AMENDMENT TO
MEMORANDUM OF AGREEMENT
AMONG
**THE UNITED STATES GENERAL SERVICES ADMINISTRATION,
THE ADVISORY COUNCIL ON HISTORIC PRESERVATION,
THE DISTRICT OF COLUMBIA HISTORIC PRESERVATION OFFICE,
THE NATIONAL CAPITAL PLANNING COMMISSION,
AND
THE UNITED STATES DEPARTMENT OF HOMELAND SECURITY,**
REGARDING THE
**DEVELOPMENT OF THE INTERAGENCY SECURITY COMMITTEE (ISC) LEVEL 5
PERIMETER SECURITY IMPROVEMENTS
AT ST. ELIZABETHS NATIONAL HISTORIC LANDMARK,
WASHINGTON, DC**
("Agreement")

NORTH SLOPE STABILIZATION MEASURES

Grading Study- Option 2 (2:1 Slope) Revised
 ST. ELIZABETHS SECURITY FENCE @ NORTH PROPERTY LINE

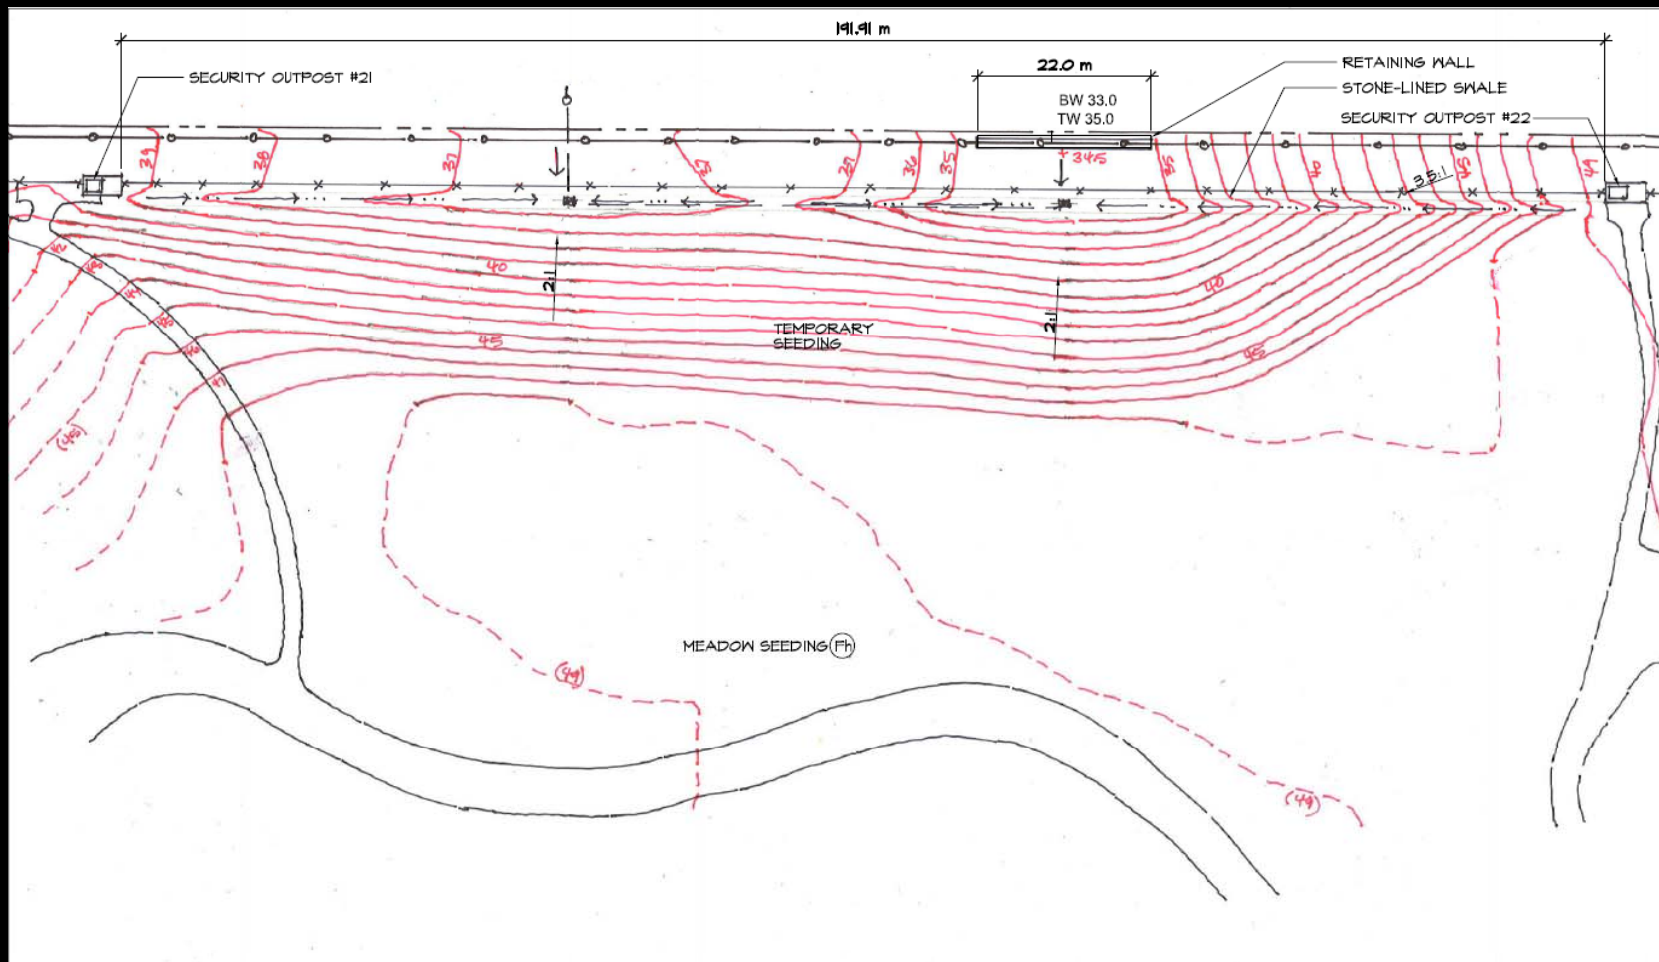
- Design revisions for the stabilization of the North Slope include:
 - Remove invasive succession tree growth along the northern slope and restore it to its historic open condition;
 - Remove unstable rubble fill and reduce the incline of the slope from 1:1 to 2:1;
 - Incorporate drainage swales to support storm water management improvements;
 - Eliminate the retaining wall beneath the inner perimeter fence

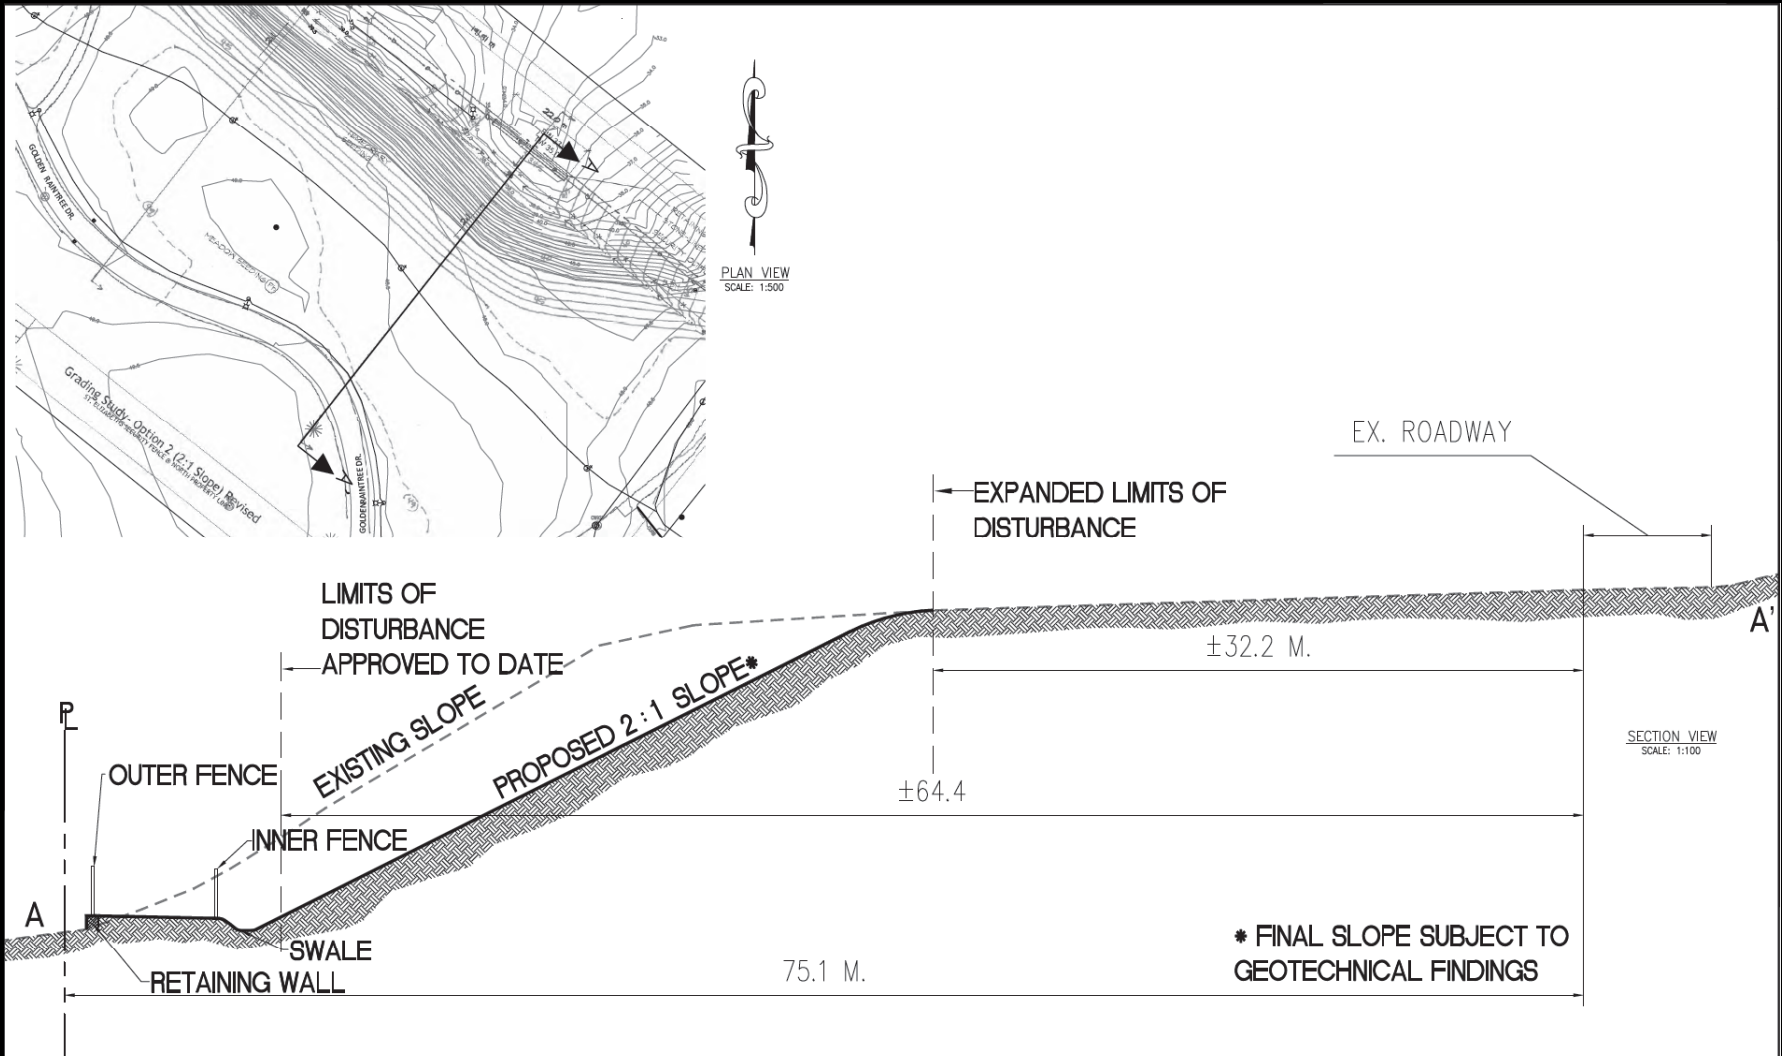
1. Amend the LOD identified in the Construction Staging Plan (Exhibit 4) to include the slope stabilization measures, as depicted herein. This amendment, in its entirety, is integrated into the MOA as Exhibit 4, superseding all previous versions of Exhibit 4.
2. Add the North Slope Stabilization Measures as Exhibit 16 to revise the design of the perimeter fence at the North Slope location and accommodate for slope stabilization measures.
